**DISTRICT 3 POLICE STATION TARGET HARDENING**

**ADDENDUM #1**

**FEBRUARY 15, 2013**

**DISTRICT 3 POLICE STATION TARGET HARDENING  
9045 E. VIA LINDA  
PROJECT G1207  
BID NO. 13PB030**

103 NEW SECURITY WALL NO SCALE

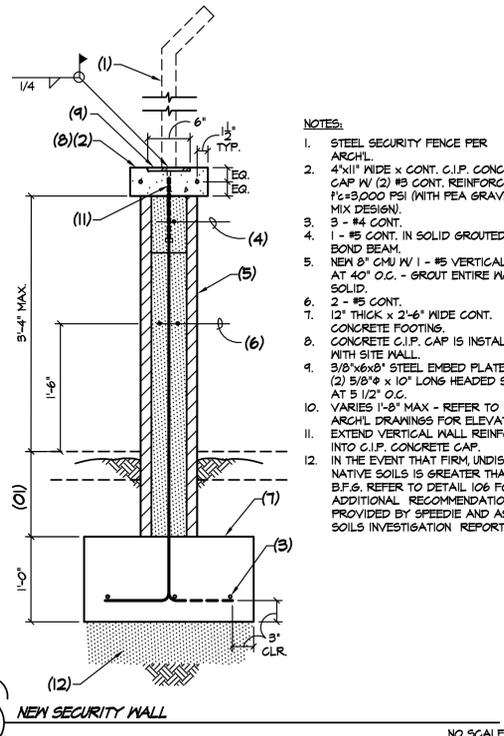
- Plan Sheet S3.1, labeled Addendum No. 1, Details 103, New Security Wall, and Detail 108, Stepped Wall Footing at Roof Drains, General Note to the Contractor: The Contractor shall anticipate native soils in excess of 1'-6" below finished grade. The Contractor shall construct Detail 103 and Detail 108 in accordance with Detail 106, Footing Recommendations when native soil is greater than 1'-6" below finished grade. All costs associated with complying with this requirement shall be included in the appropriate bid item listed in the bid schedule.
